AMENDMENT NO. 1 DECEMBER 2022

**IS 8953 : 2006 62 PERCENT ALUMINA BRICKS AND BLOCKS FOR BLAST
FURNACE — SPECIFICATION**

(First Revision)

Figure 1

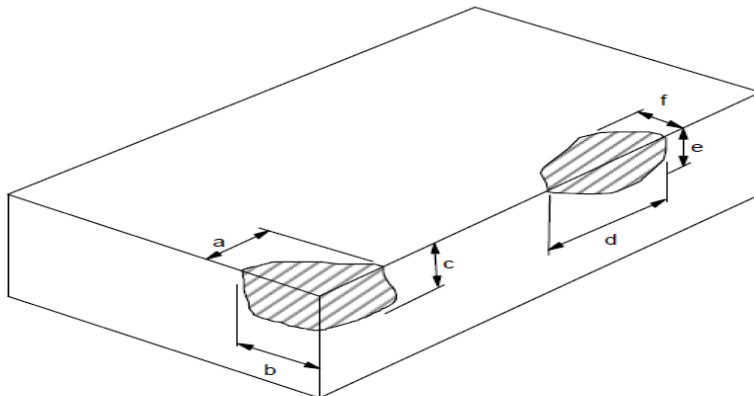
[Page 1, clause 5 a)] — Substitute the following for the existing:

‘Chipped corners and edges:

- i) The dimensions of the defect/damage on the corners and edges shall not exceed the following:

For Corner damage: $a + b + c \leq 50 \text{ mm}$ (*see* Fig. 1)

For Edge damage: $d + e + f \leq 50 \text{ mm}$ (*see* Fig. 1)

NOTE — If two of the dimensions are less than 5 mm, the damage will be ignored.

- ii) An item shall have no more than two damages, corner and/or edge.’
